Date: March 17, 2022	Job #5734
Attn:	
Re: PROPOSED BUILDING ADDITIONS - SITE PLAN	
22 Friars Drive	
Hudson, NH

**RE: PROPOSED BUILDING ADDITIONS
22 FRIARS DRIVE
HUDSON, NEW HAMPSHIRE**

Pursuant to our recent telephone conversation regarding the above referenced project please note our responses to the additional plan review comments that you both provided during the call.

SIDEWALK SKETCH PLAN
MAP 209, LOT 4
22 FRIARS DRIVE
HUDSON, NH
03/16/22

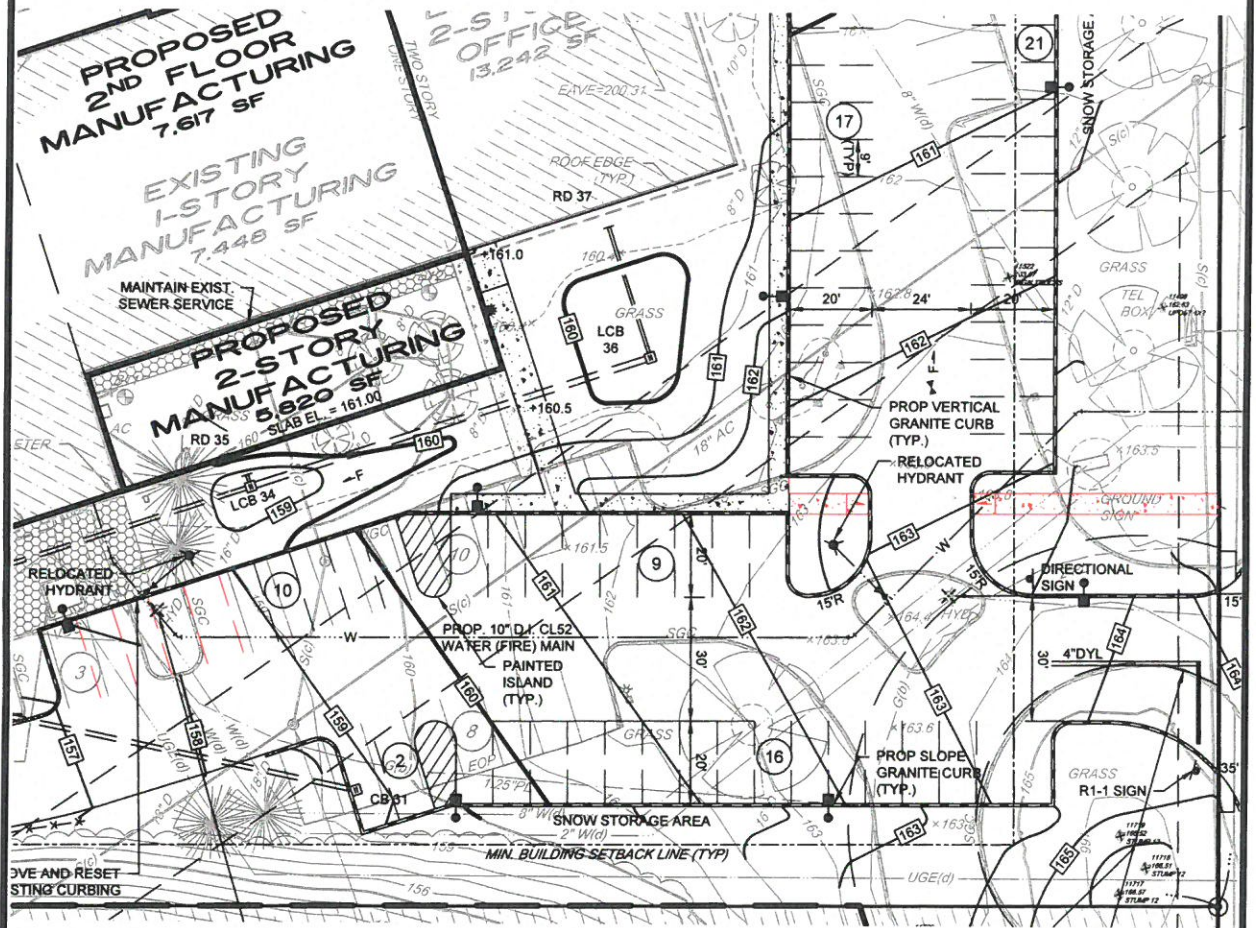
3. Please find attached a sketch plan showing the sidewalk connection from Friars Drive to the on-site sidewalk network that leads to the building entrances. If acceptable we will add this information to our final plan set.
